**Our Case Number:** ACP-323980-25

**Re:** Proposed Water Supply Project for the Eastern and Midlands Region  
in the counties of Clare, Limerick, Tipperary, Offaly, Kildare, and Dublin.

RE: (A) Direct planning application to An Coimisiún Pleanála under section 37E of the Planning and Development Act as amended in respect of a Strategic Infrastructure Development (Proposed Water Supply Project Eastern and Midlands Region) (ACP Ref. 323980); and  
(B) Uisce Éireann Compulsory Purchase (Water Supply Project Eastern and Midlands Region) Order, 2025 (ACP Ref 323982)

Peamount Healthcare wishes to make a number of observations on the above referenced Strategic Infrastructure Development application (the **Proposed Development**) by Uisce Éireann (UÉ). Peamount Healthcare also wishes to object to the draft Compulsory Purchase Order (CPO), and particularly the CPO of Plots No ACQ09a.2172 and ACQ09a.2175 on Drawing No IW/10001814/CA/09a.

**APPENDIX 1: PEAMOUNT HOSPITAL MAP**

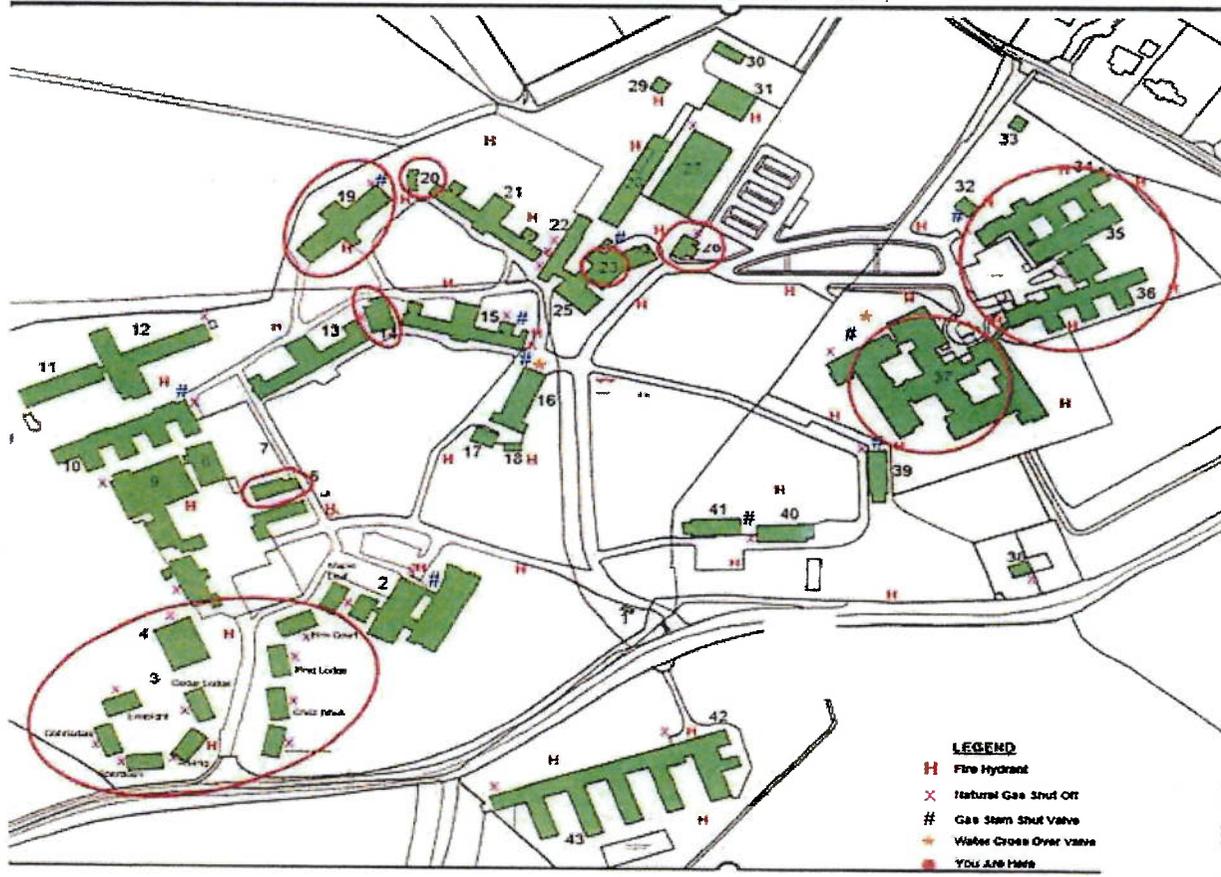
- 2.4 Peamount Hospital is located immediately adjacent to the Proposed Development Termination Point Reservoir (TPR). Please see **Appendix 1** to this submission that sets out the locations of the inpatient facilities at Peamount Hospital relative to the proposed construction access road and TPR.

- 2.5 Of utmost concern to Peamount Hospital are the likely significant construction effects the Proposed Development will have on Peamount's patient population, and particularly St. Brid's Neuro Disability Unit as shown in Appendix 1.

- 2.6 St Brid's is a highly specialised unit for people with traumatic and progressive neurological disabilities requiring consultant-led interdisciplinary care with 24/7 specialised nursing care and support. The centre provides a homely environment to encourage the enhanced participation of residents and families while also meeting the needs of this very complex patient group. St Brid's is located immediately adjacent to the Proposed Development TPR site boundary at the termination of the proposed construction access road.
